Application for Assessment of a Site Investigation Report (Contaminated Land) Checklist

Third Party Reviewer Certification Report:
Logan Greyhound Facility, Slacks Creek,
Queensland (Lot 658 on Plan SL12298)

**Logan Greyhound Facility, Slacks Creek,
Queensland (Lot 658 on Plan SL12298)**

Response to TPR Comments “Contaminated Site Investigation, Logan Greyhound Racing Facility, Cronulla Park”

LOCALITY: SLACKS CREEK
LOGAN GREYHOUND FACILITY
GROUND SITE INVESTIGATION
Figure 3
Existing Topography & Drainage Patterns

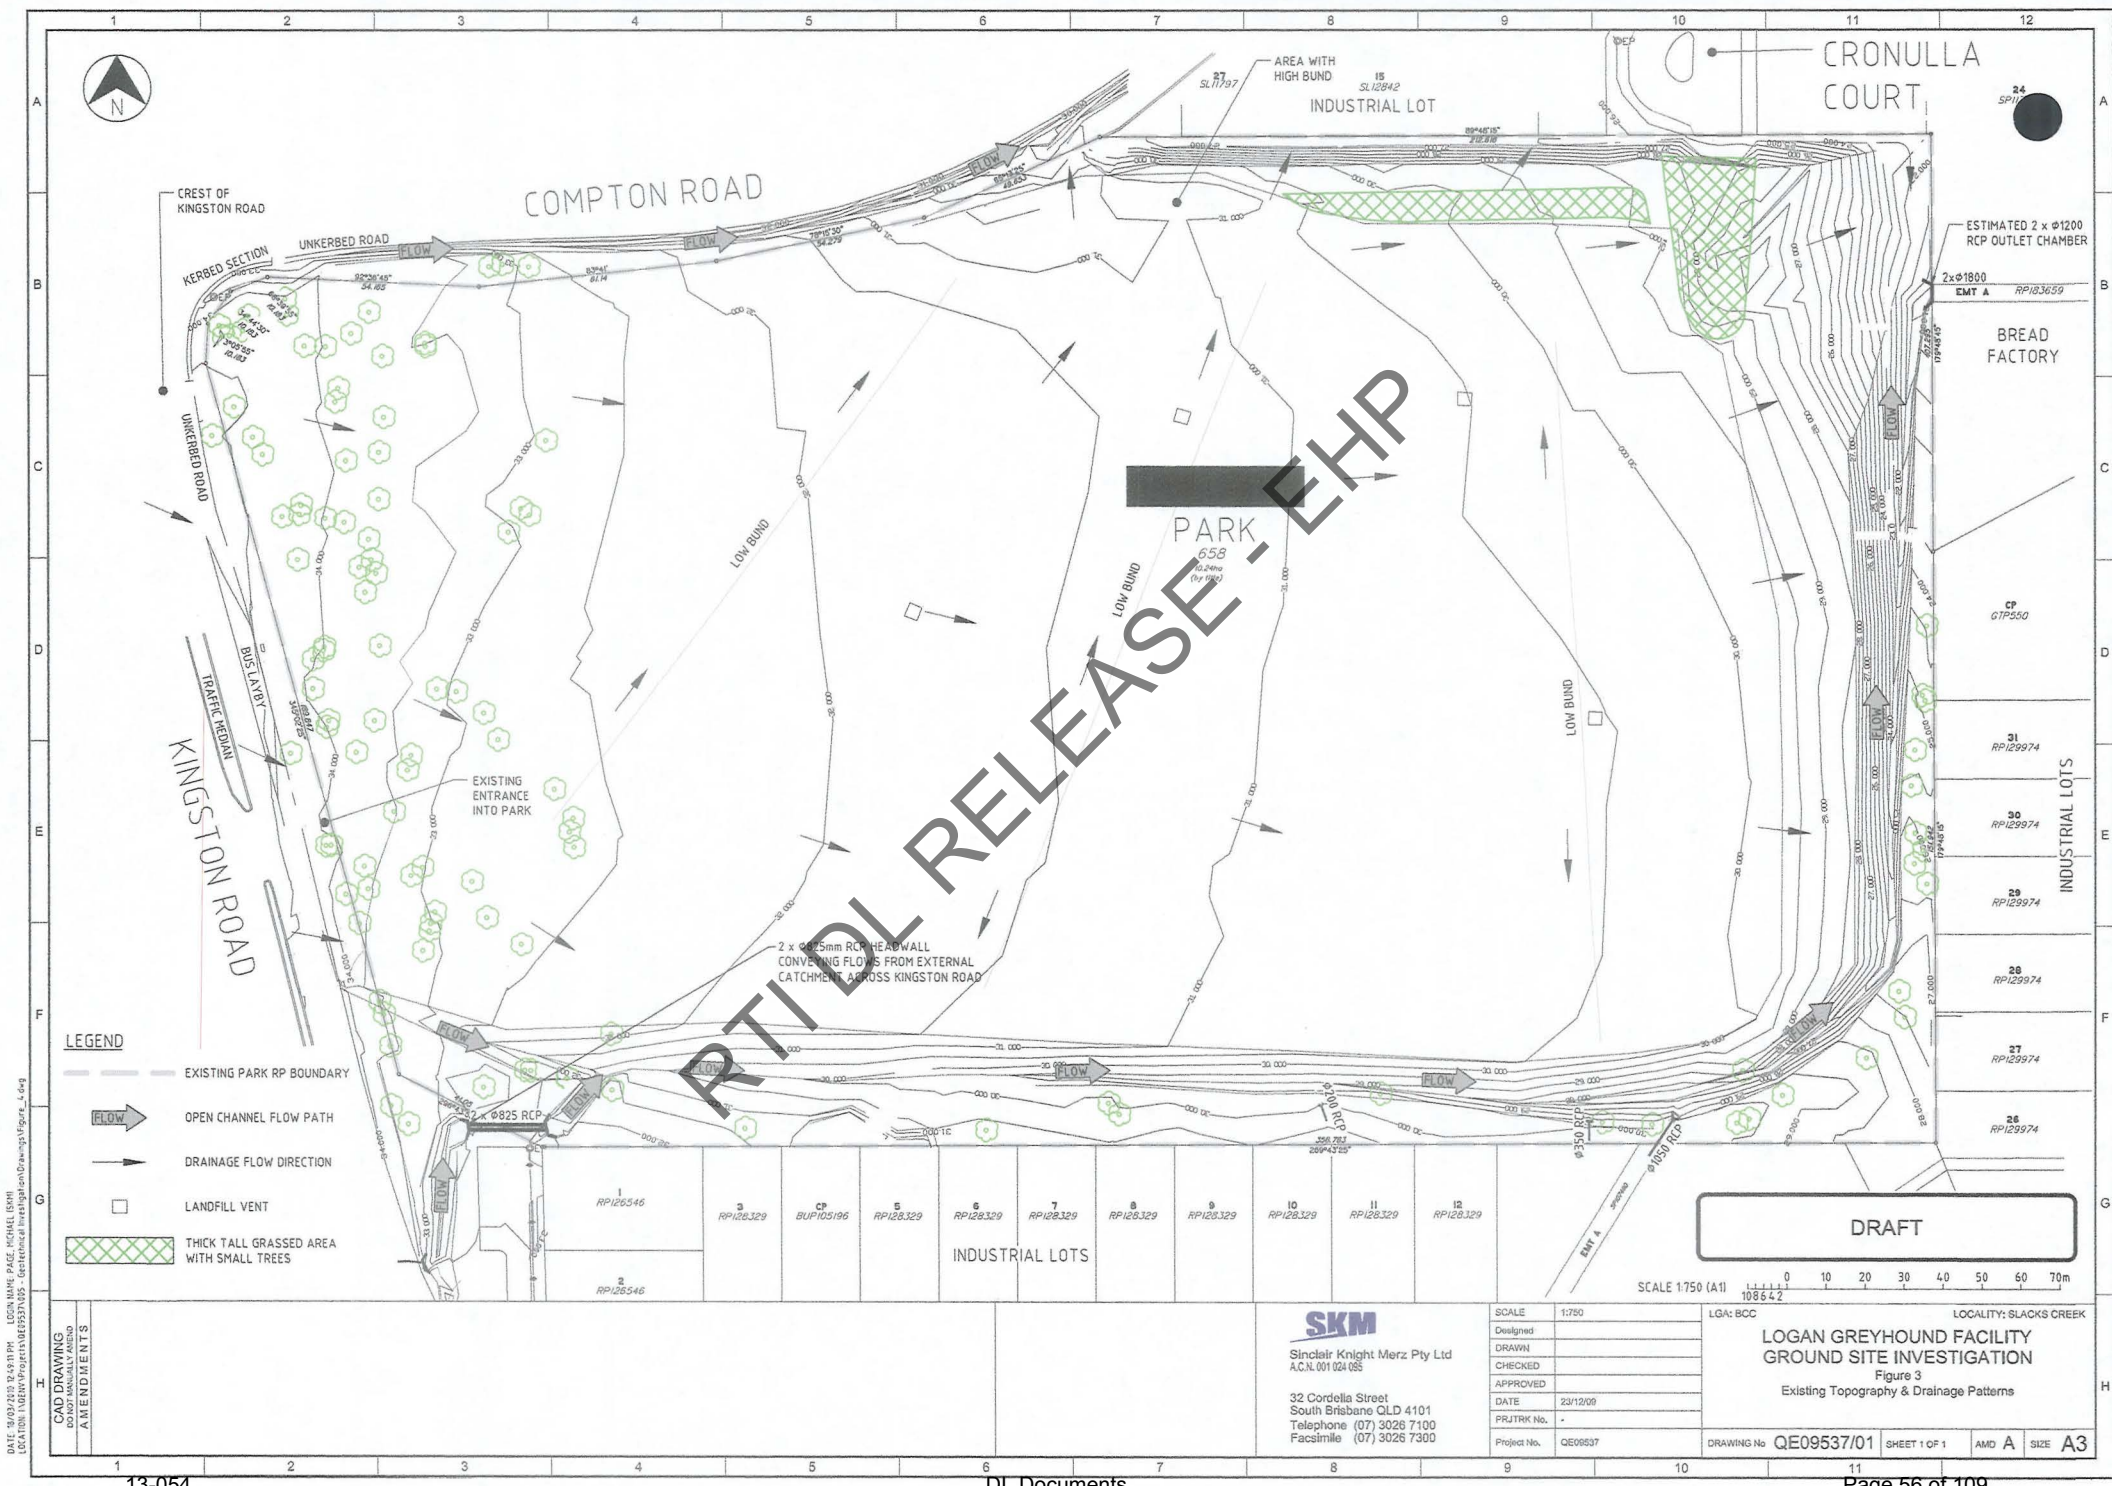
Figure 3

Scale bar states 1:750 at A1, yet scale in title is 1:750 and print out is A3 – please clarify/amend.

Note earlier comment about basement and venting. Check scales as only printed in A4 not A3 or A1 (Figure E1 and Figure 3). Note also Figure 3 states both A3 and A1.

- Figure has been corrected.

- Figure has been corrected.
